ADDENDUM 01

Keyo Electrical Service Upgrade University of Maine

Re Addendum No. 1 to the Construction Documents for:

University of Maine
Keyo Building Electrical Service Upgrade
Orono, Maine
Project No. 24265

1 BASEMENT FLOOR PLAN POWER AND SYSTEMS
SCALE: 1/8" = 1'-0"

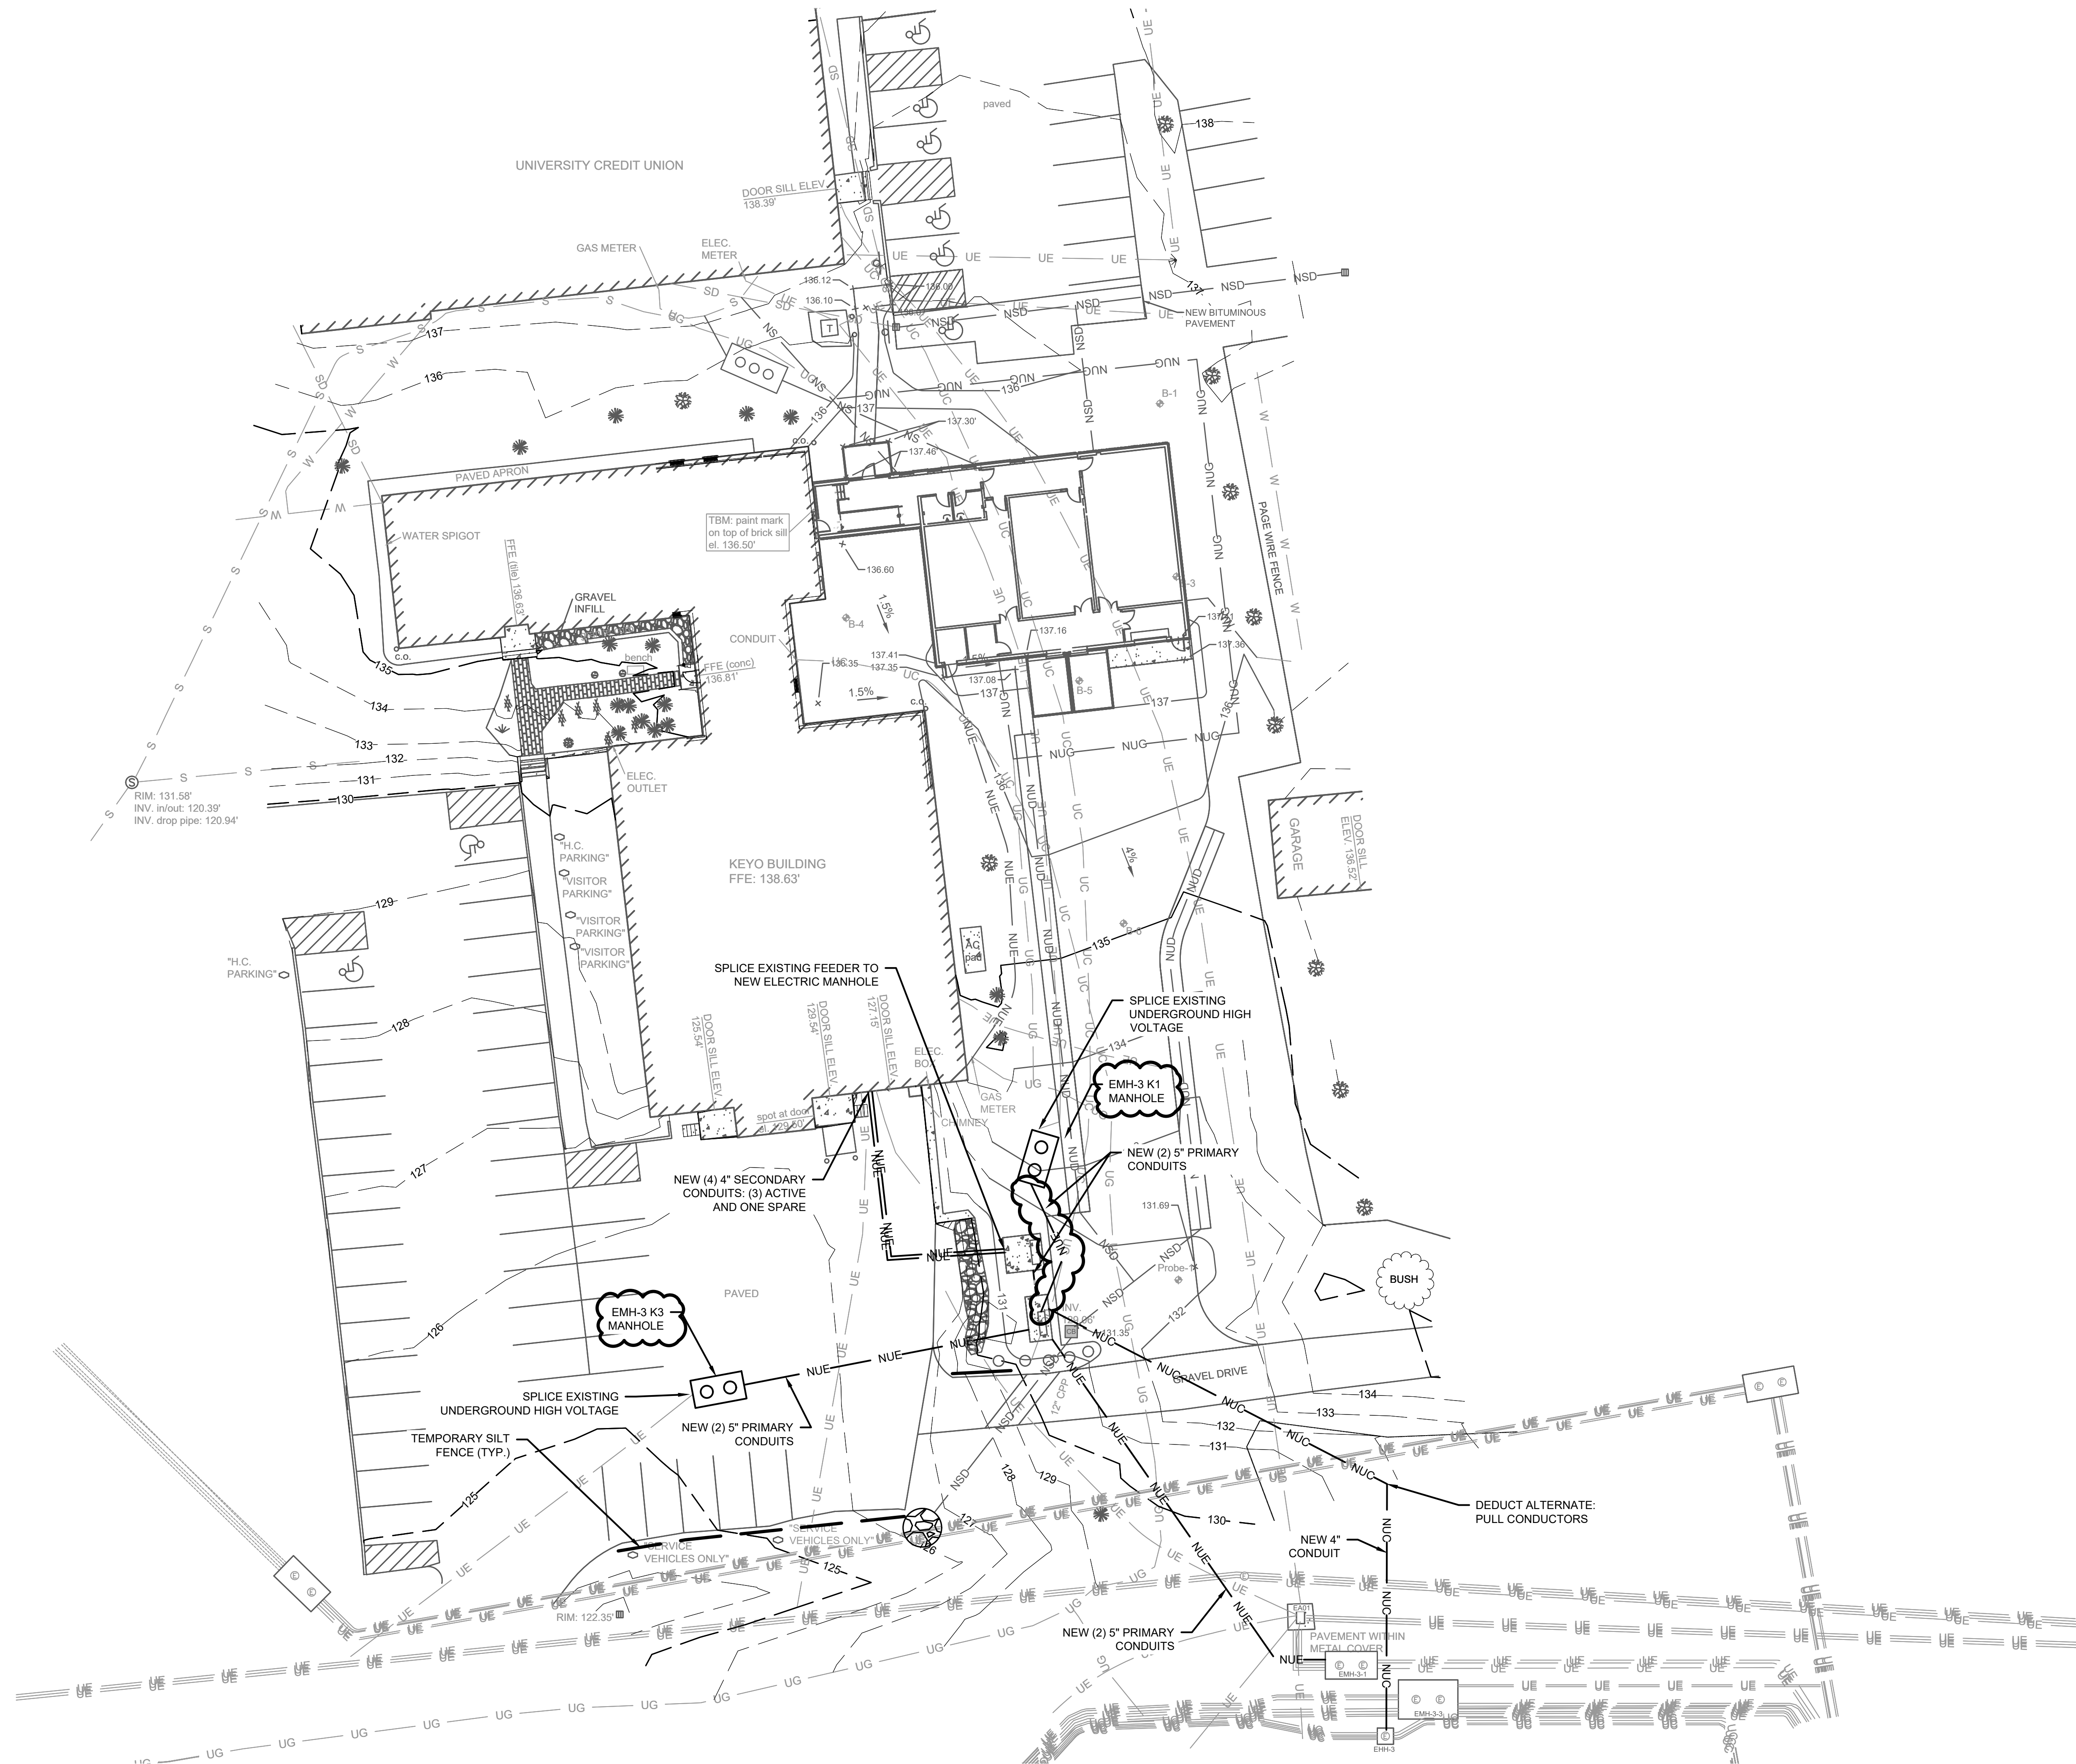
- Q7. Keynote P01 on drawing E20-0 states the EC shall route conduits for the Food Innovation Lab project through the boiler (furnace) room. Please confirm quantity of conduits and size of conduits. Will the conduits for this project need to penetrate the foundation or will the Food Innovation project bring their conduits into the boiler room for continuation by the Keyo project?

- A7. Two 4" conduits for 800-amp service shall be required. Conduits shall be routed through the boiler room and extend 5-feet beyond foundation wall for tie in as a part of the food innovation addition project. Drawing E20-0 has been updated as a part of this Addendum to clarify requirements.**

- P01 COORDINATE ROUTING OF TWO 4" CONDUITS THROUGH BOILER (FURNACE) ROOM. EXTEND FIVE FEET BEYOND FOUNDATION WALL FOR FOOD INNOVATION BUILDING ADDITION PROJECT TO TIE INTO.
- P02 PROVIDE 120VOLT CIRCUIT FOR EXHAUST FAN. TIE TO NEAREST PANEL WITH AVAILABLE 20AMP SINGLE POLE 120VOLT CIRCUIT BREAKER.

SITE UTILITY PLAN

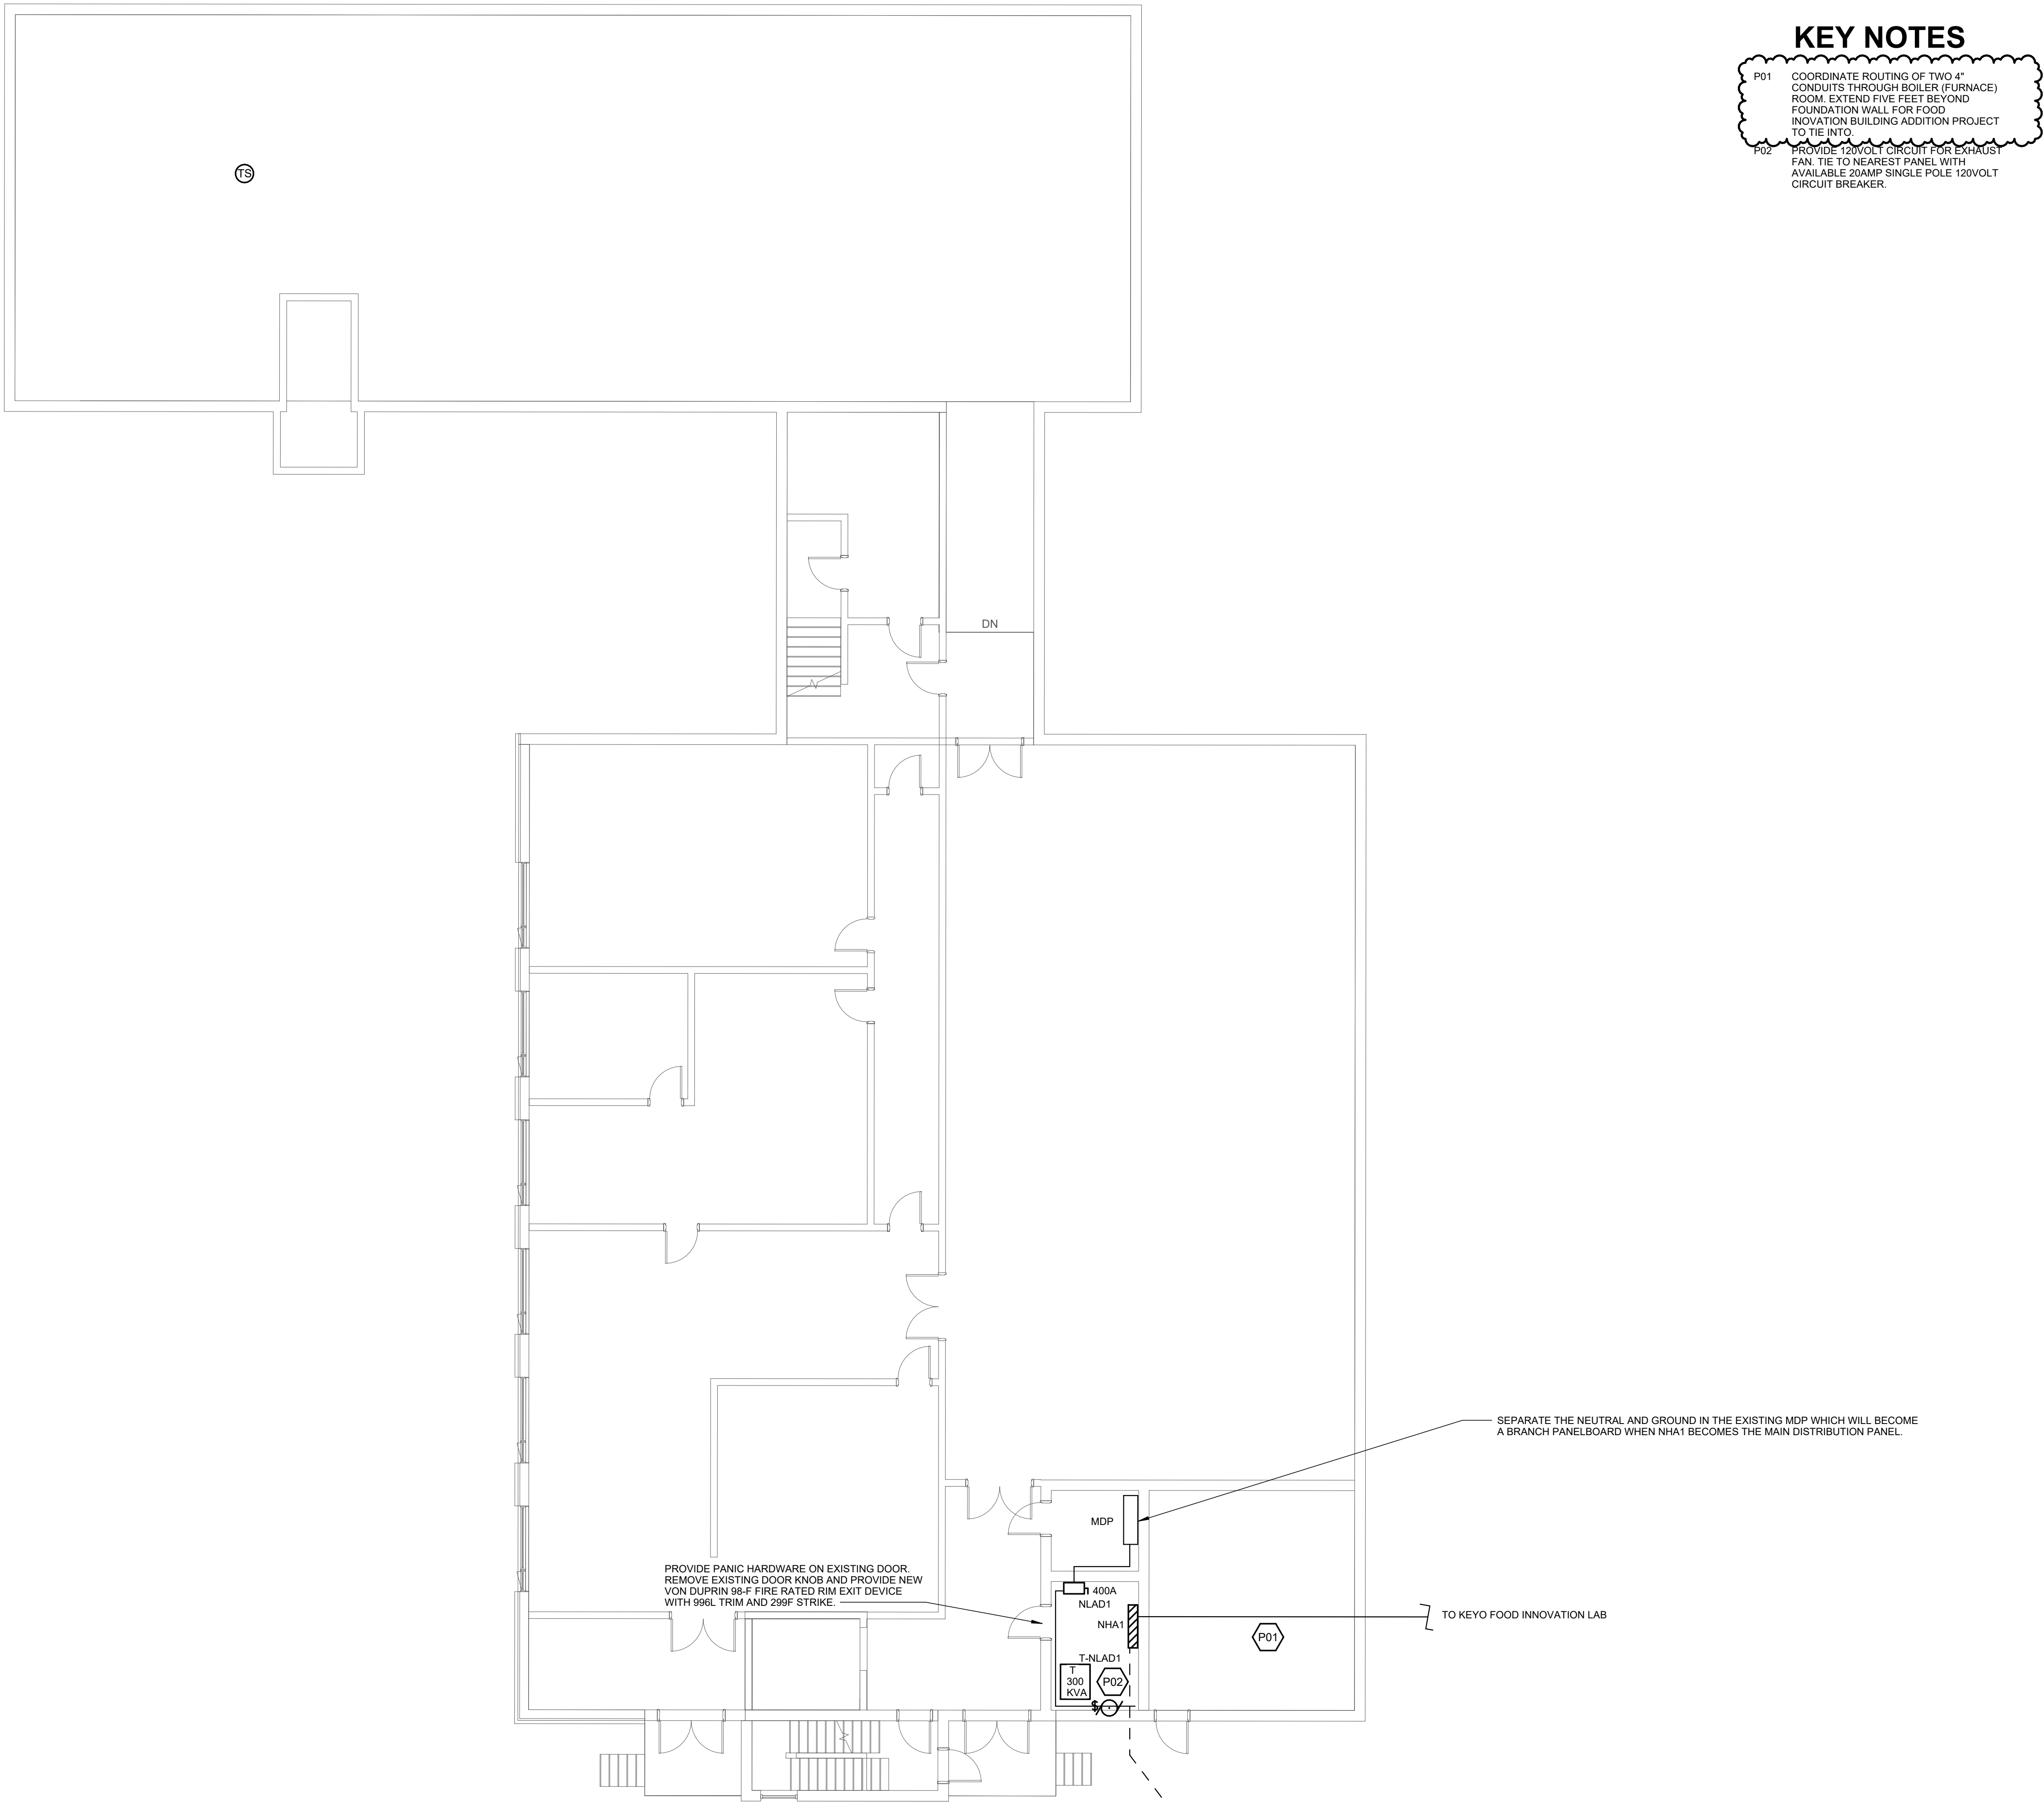
- Q5. Manholes EMH-3-K3 and EMH-3-K1 are shown on E80-1. Conversely, these manholes are not shown on C40-1. Are manholes EMH-3-K3 and EMH-3-K1 being used in this project? The new electrical manholes on drawings C40-1 and E80-1 appear to have conflicting locations. The electrical conduits also appear to conflict between the two drawings. Please confirm quantity and locations of manholes and conduits.

- Q8. E80-1 shows (3) – 4" secondary conduits run from the exterior pad mount transformer to NHA-1. Conversely, C40-1 shows (4) – 4" secondary conduits run from the exterior pad mount transformer to NHA-1. Of these (4) conduits, (3) are utilized and (1) is spare. Can you please confirm the quantity of secondary conduits run from the exterior pad mount transformer to NHA-1? How many are utilized? How many, if any, are spares?

- A5. Manhole labels to be added to C40-1 drawing to match E80-1 drawing. Locations of manholes and underground conduits on drawings has been adjusted to ensure exact location matching as a part of this Addendum.**
